KENYA PETROLEUM REFINERIES LIMITED

REF: KPRL/OT/024.016/2024-2025

CLARIFICATION NO 1: TENDER FOR MAINTENANCE WORKS ON TANK 304

Figure 10: Examples of a suitable design of tankside fast-flush facility, without (top diagram) and with glass 'visi-jar' (bottom diagram)

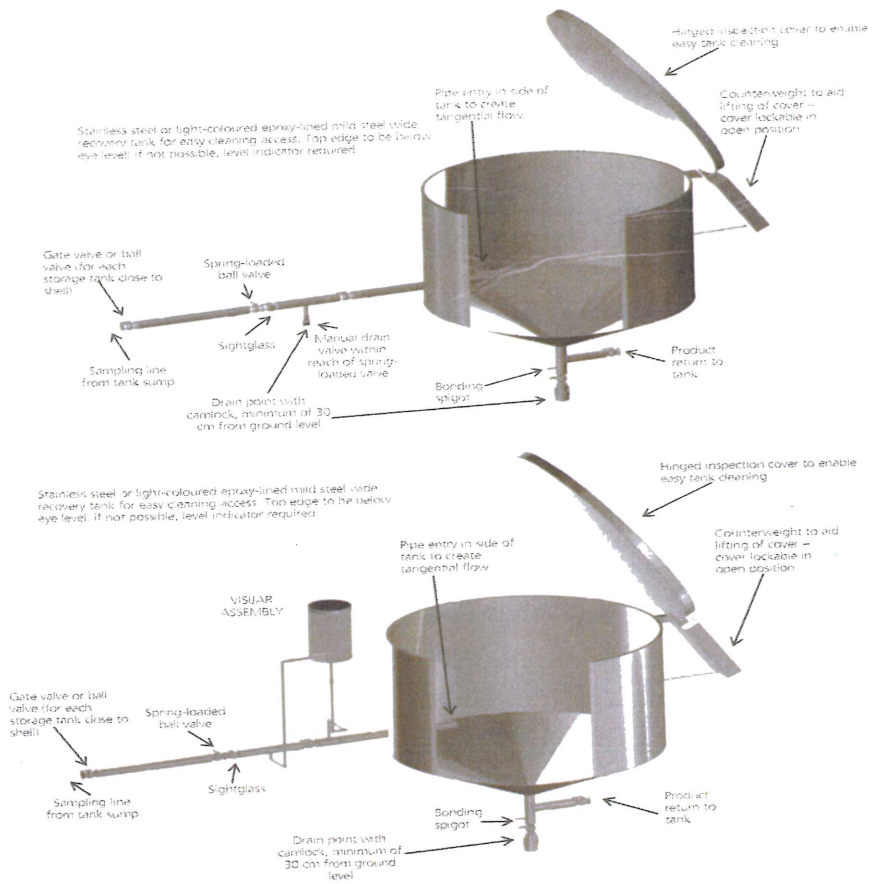
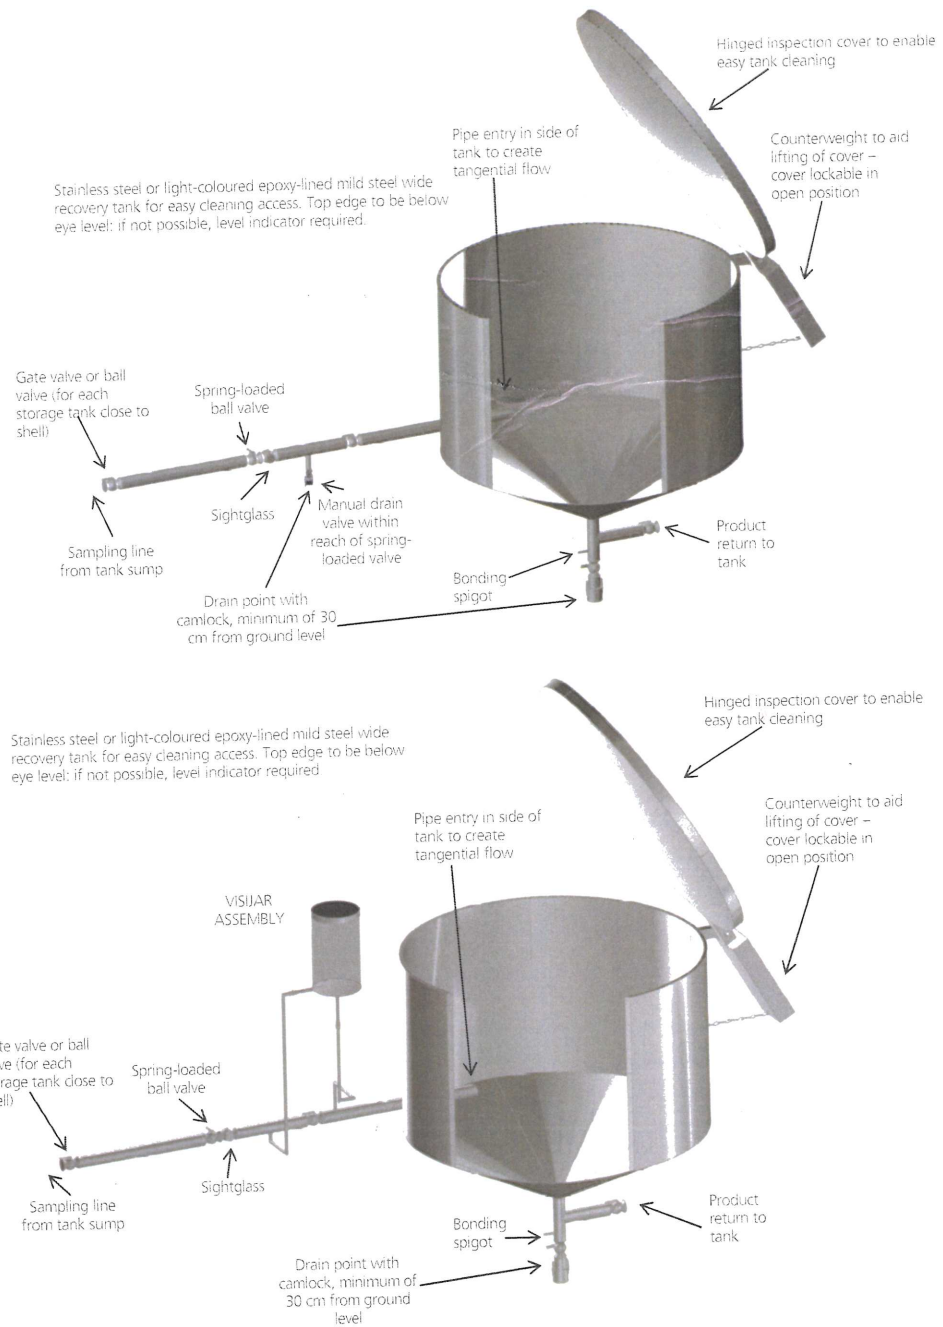
ITEM	QUERY RAISED	CLARIFICATION PROVIDED
1.	I am writing to seek clarification regarding the availability of 3-phase power at the Tank 304 site. Could you please confirm whether 3-phase power is available on-site, or if the contractor will need to provide a diesel welding generator for the scope of work?	Under the " Preamble to Bill of quantities Item 1 (g) " it is the scope of the contractor to provide electricity for the works. KPRL does not have 3-phase power at Tank 304.
2.	We hereby request for extension of submission date by one week to allow us submit a competitive bid	Due to strict timelines, there will be NO extension of submission date.
3.	Kindly share the Drawing for Fast Flush Facility-T304	The Drawing is herein attached and also available on our website www.kprl.co.ke
